**TOWN OF NEWBURGH  
PLANNING BOARD  
TECHNICAL REVIEW COMMENTS**

**PROJECT: LANDS OF MANN (FORMERLY MARTIN)**  
**PROJECT NO.: 15-09**  
**PROJECT LOCATION: SECTION 2, BLOCK 2, LOT 22.1**  
**REVIEW DATE: 13 JUNE 2016**  
**MEETING DATE: 16 JUNE 2016**  
**PROJECT REPRESENTATIVE: HERITAGE LAND SURVEYING**

**PROPOSED CONDITIONS PLAN**

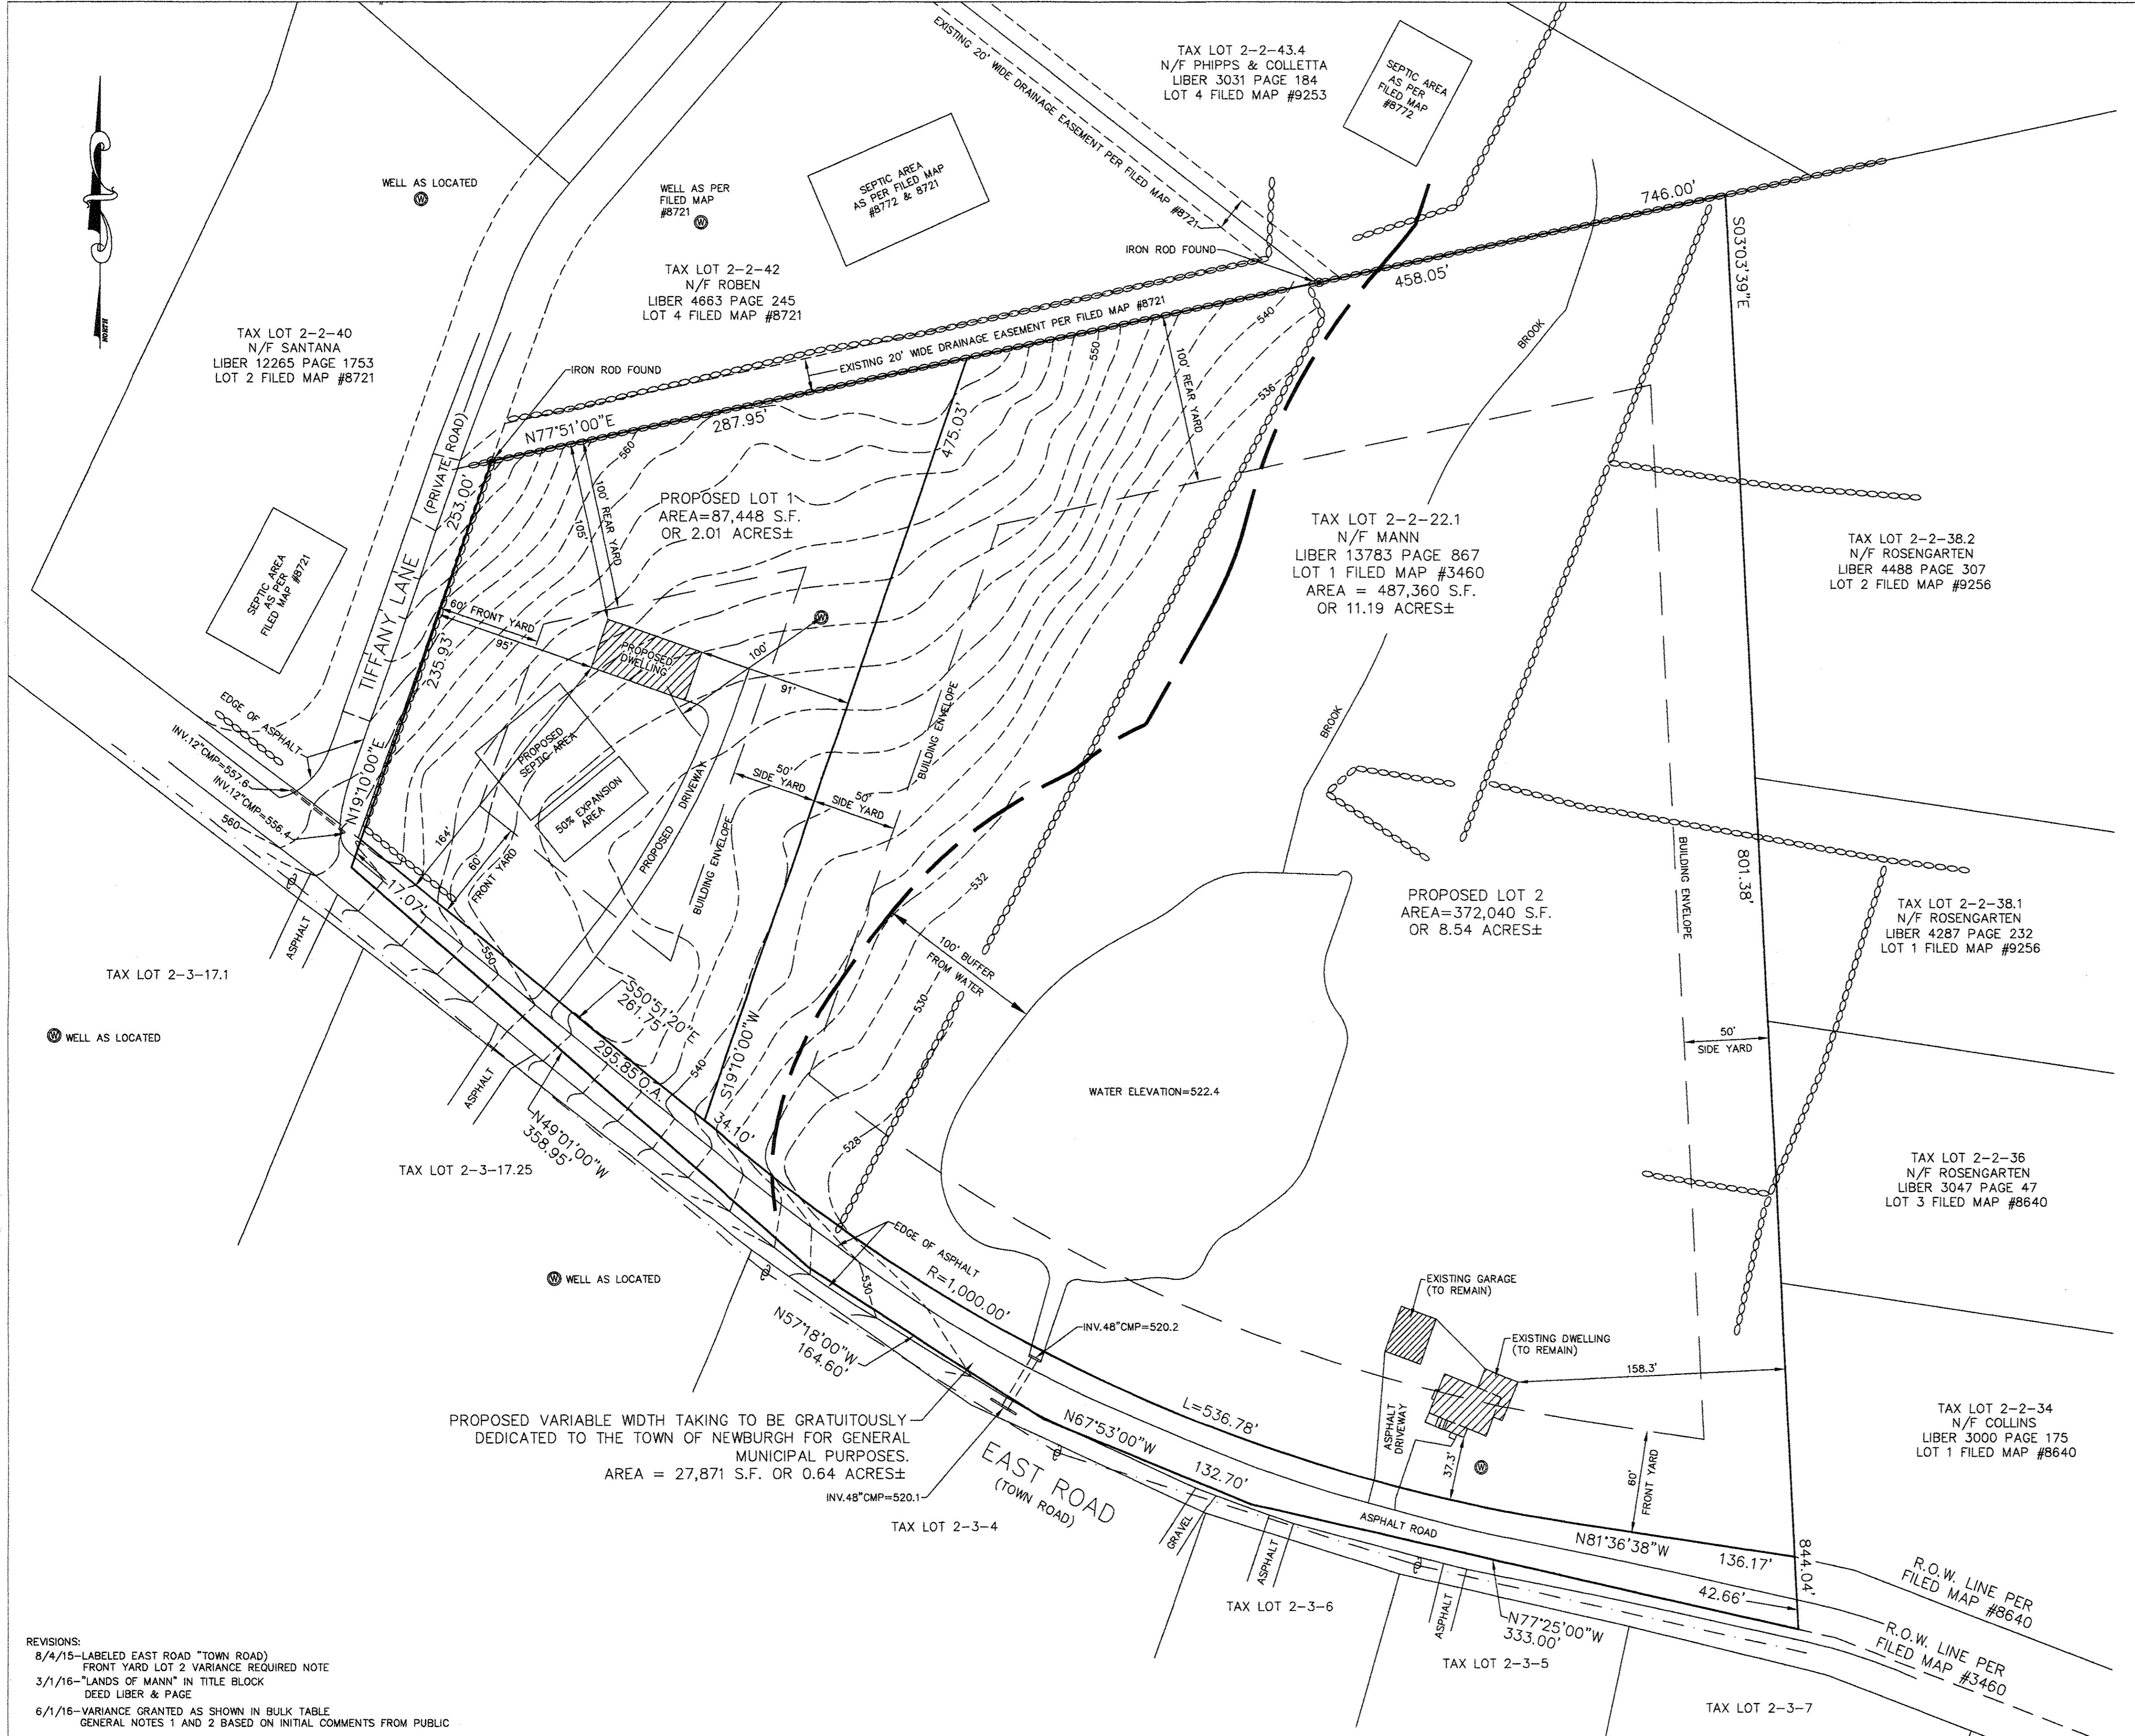
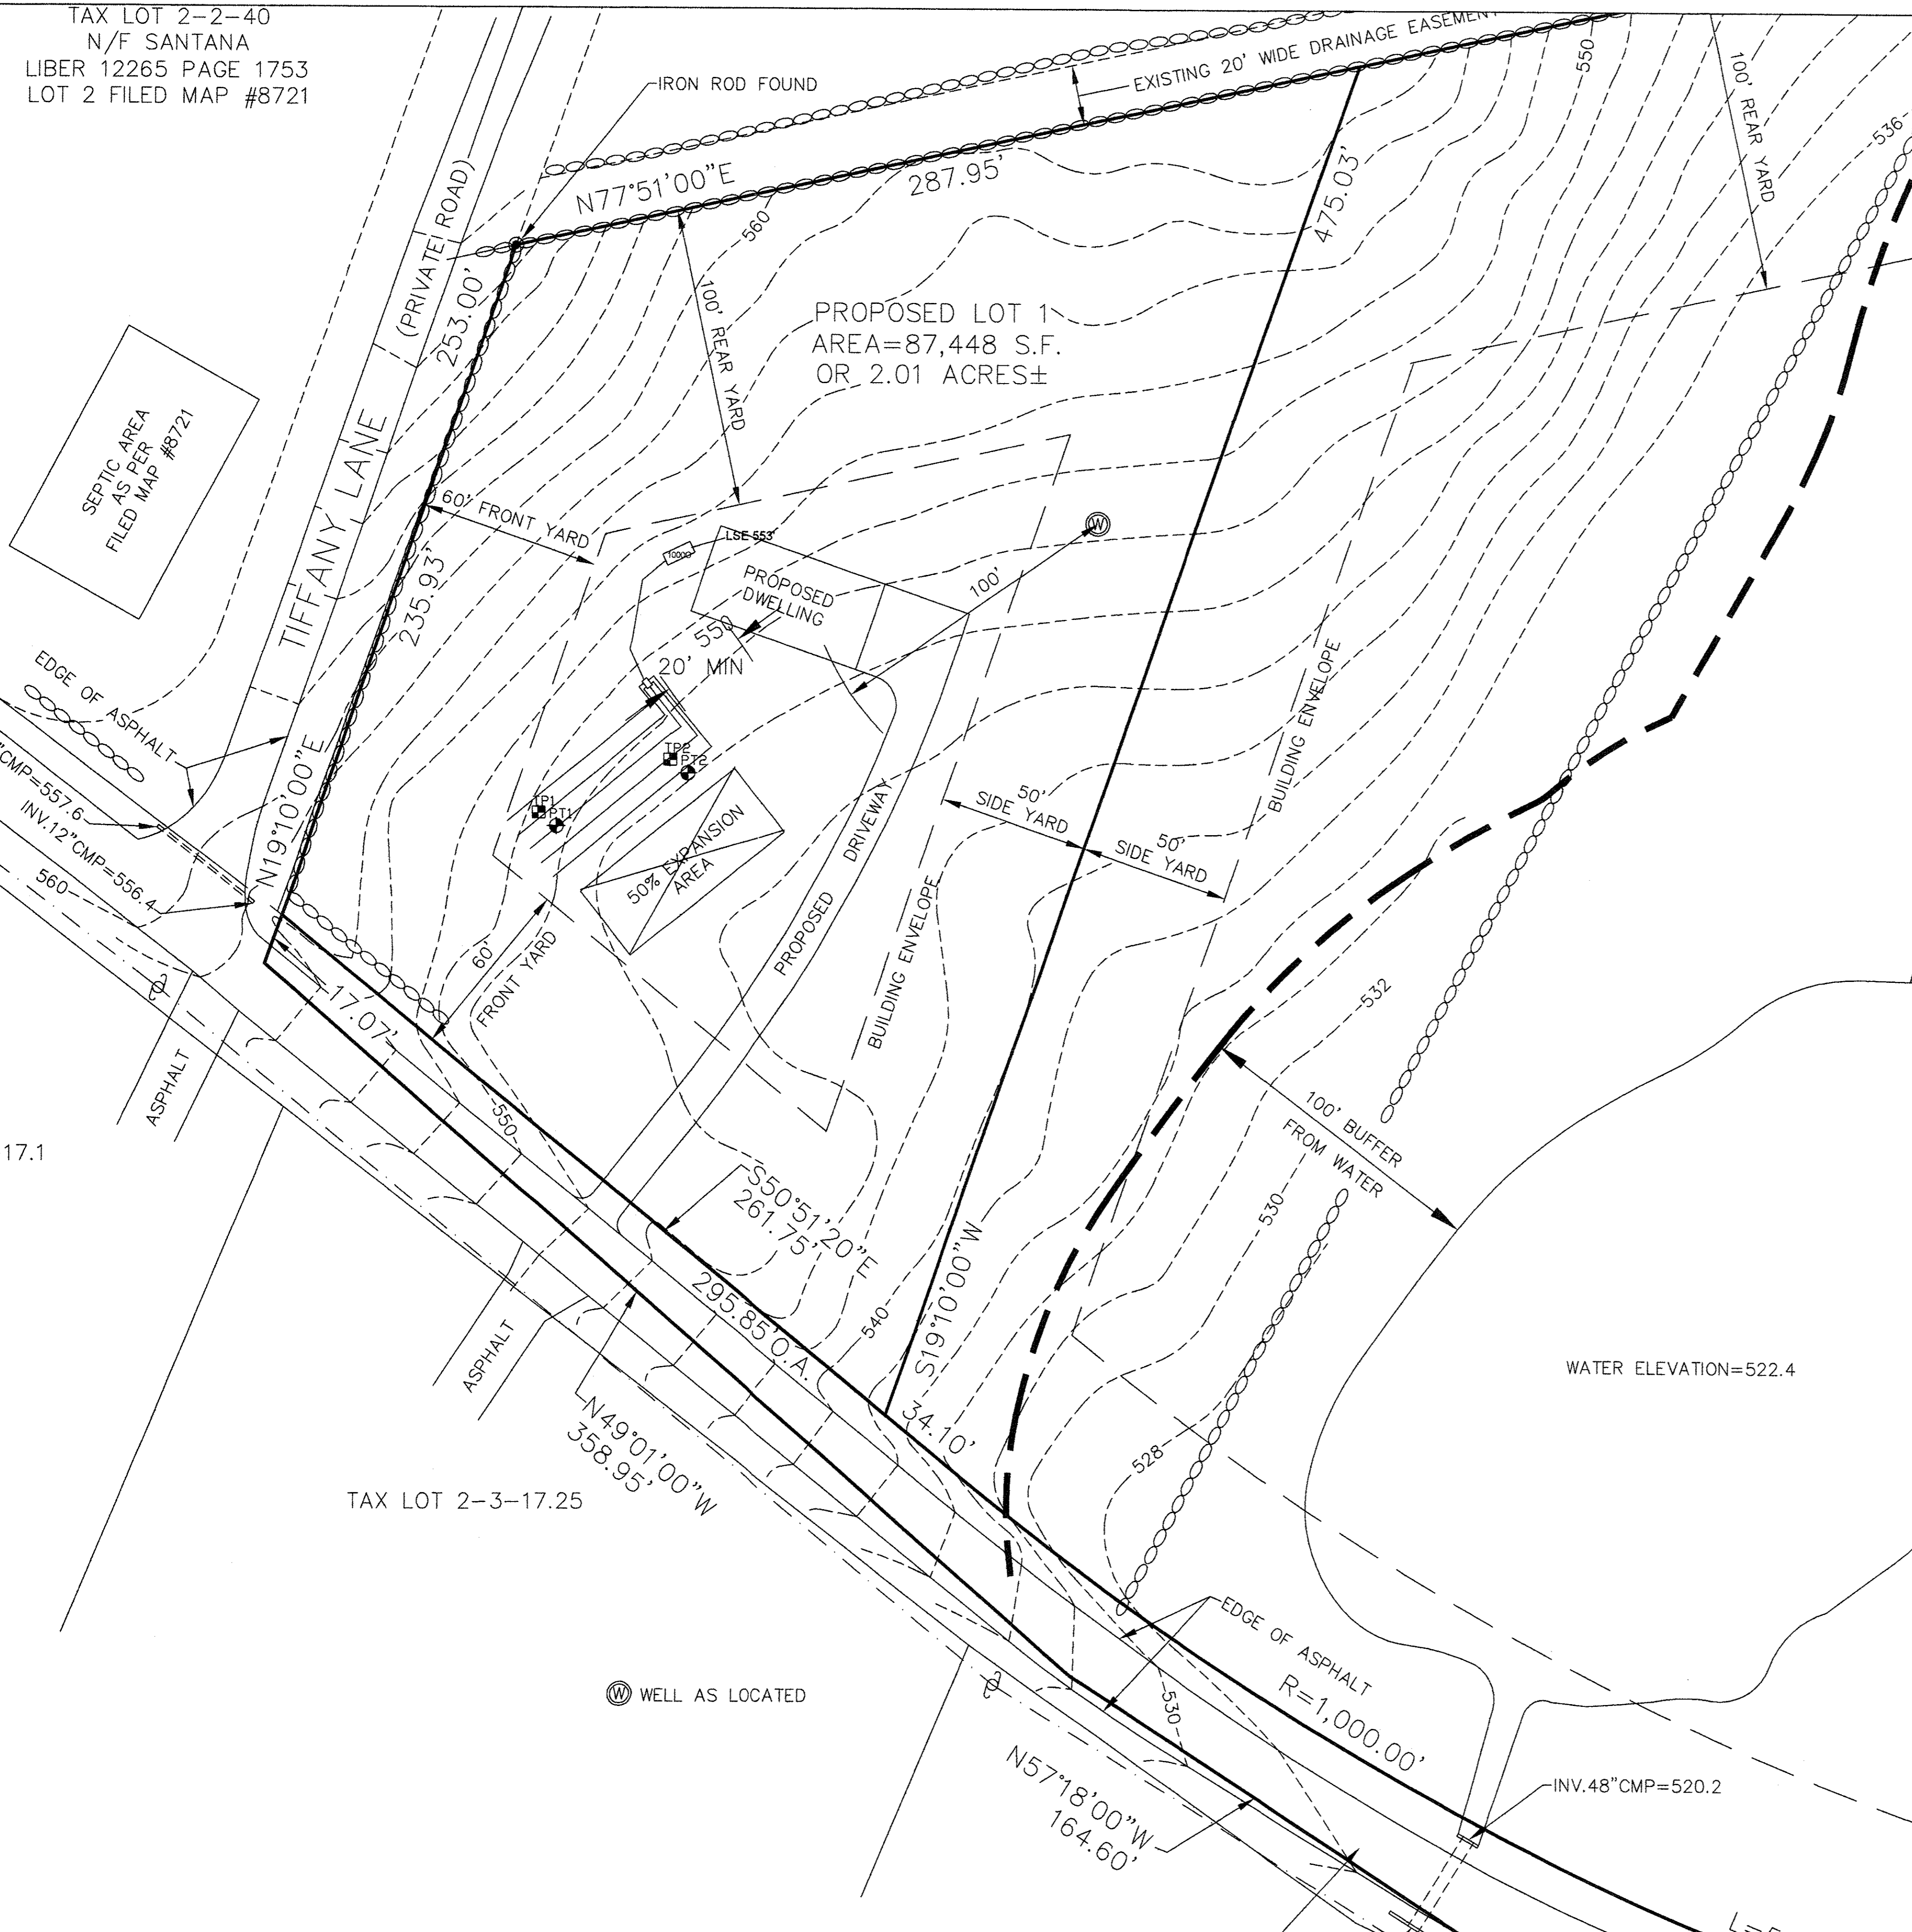
1. Zoning Board of Appeals granted a variance for pre existing non conforming lot front yard set back on the existing parcel.
2. Project identifies a proposed gratuitous dedication to the Town of Newburgh for Highway purposes. Documentation of this should be provided as a condition.
3. A note should be added to the septic plans requiring that prior to a Certificate of Occupancy a certification and as built map be submitted to the Code Enforcement Office.
4. Driveway location should receive approval by the Highway Superintendent.
5. It is noted that the subsurface sanitary sewer disposal system is designed to support a 3 bedroom maximum house.
6. A well detail should be depicted on the detail sheets.
7. A driveway culvert should be depicted at the proposed drive for lot 1.
8. A public hearing is required for the subdivision.
